# MODBAR TECHNICAL BULLETIN #48

## Longer group head screws (M5x20)

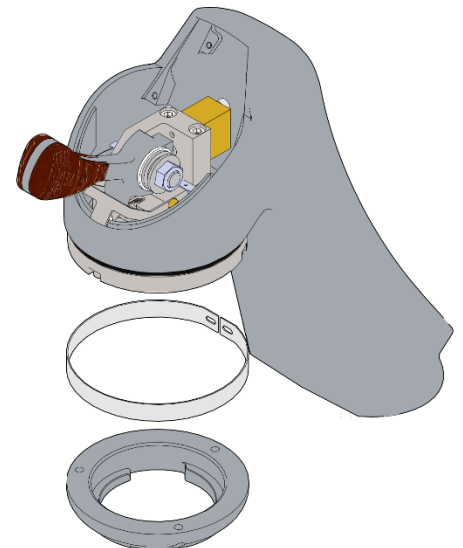
We are pleased to inform you that we are now installing longer tap head screws on the bayonet ring for Modbar AV. This replaces the previous screw, providing a 4mm increase in length to enhance installation and connection security.

This change is incorporated into:

Modbar AV Mod + 1 Tap, beginning with serial number **MB008645**

Modbar AV Tap Only, beginning with serial number **ET004419**

New part number: **I.1.224** SCREW M5X20 PHILLIPS ROUND-PAN S/S A2
